# 1986 - 1987 Corvette: Service Bulletin: Clutch Master Cylinder Push Rod Bushing

**Subject:** Clutch Master Cylinder Push Rod Bushing  
**Model Year:** 1986 - 1987 Corvette with Manual Transmission  
**Source:** Chevrolet Dealer Service Bulletin  
**Bulletin No:** 87-114, Section 7C  
**Date:** April, 1987

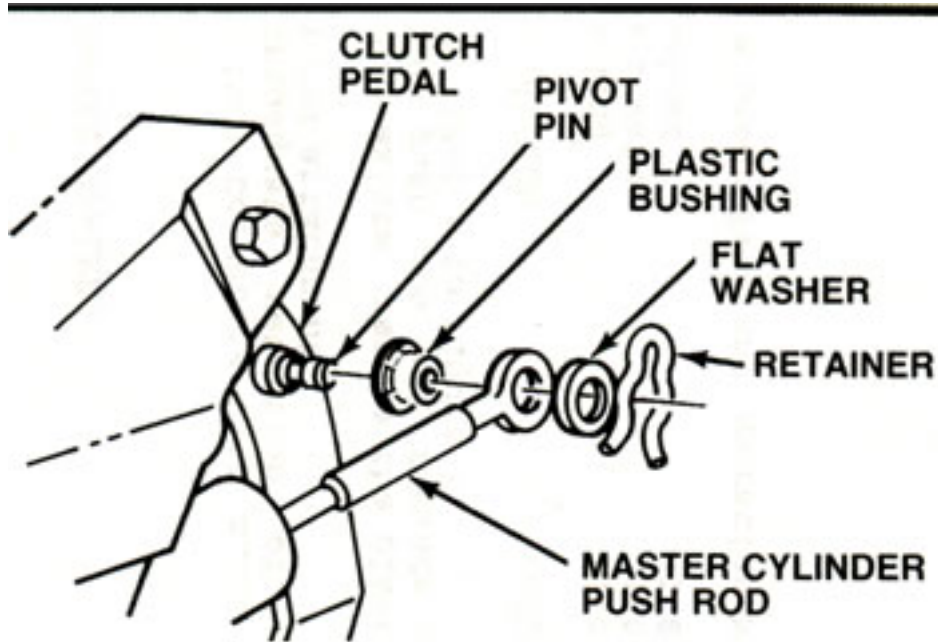
Some 1986 or 1987 Corvettes with manual transmissions may experience inadequate retention of the clutch master cylinder push rod attachment.

If the condition exists, remove the plastic bushing from the master cylinder push rod and replace with the following service parts. (Refer to Figure 1):

DESCRIPTION	PART NUMBER
Bushing	14080233
Flat Washer	120395
Retainer	148149
